NRC-96-103

Docket 50-305 Operating License DPR-43 Kewaunee Nuclear Power Plant Proposed Amendment 139a to the Kewaunee Nuclear Power Plant Technical Specifications

Description of Proposed Changes to Section TS 3.1. and Figure TS 3.1-4

Figure 1

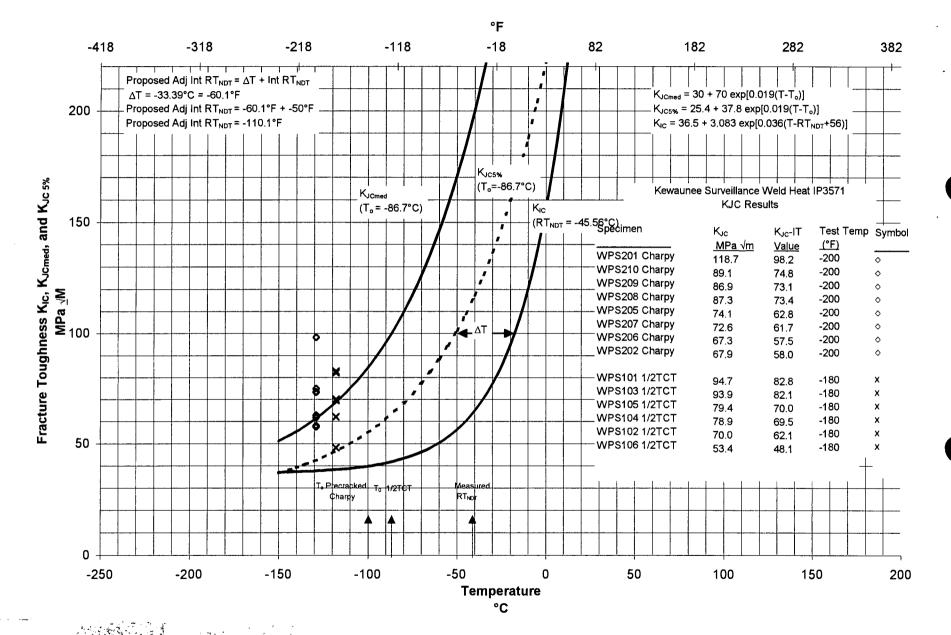
An alternative methodology to the safety margins required by Appendix G to 10CFR Part 50 has been developed by the ASME Working Group on Operating Plant Criteria. This inethodology is contained in ASME Code Case N-514. The Code Case N-514 provides criteria to determine pressure limits during LTOP events that avoid certain unnecessary operational restrictions, provide adequate margins against failure of the reactor pressure

vessel, and reduce the potential for unnecessary activation of the relief valve used for LTOP. Specifically, the ASME Code Case N-514 allows determination of the setpoint for LTOP events such that the maximum pressure in the vessel would not exceed 110% of the P/T limits of the existing ASME Appendix G; and redefines the enabling temperature at a coolant temperature less than 200°F or a reactor vessel metal temperature less than  $RT_{NDT}$  + 50°F, whichever is greater. Code Case N-514, "Low Temperature Overpressure Protection," has been approved by the ASME Code Committee but not yet approved for use in Regulatory Guide 1.147. The content of this code case has been incorporated into Appendix G of Section XI of the ASME Code and published in the 1993 Addenda to Section XI. It is expected that the next revision of 10 CFR 50.55a will endorse the 1993 Addenda and Appendix G of Section XI. As stated above, this PA uses Appendix G limits and an enabling temperature corresponding to a reactor vessel metal temperature less than  $RT_{NDT}$  + 90°F, which is more conservative than the alternative methodology contained in Code Case N-514.
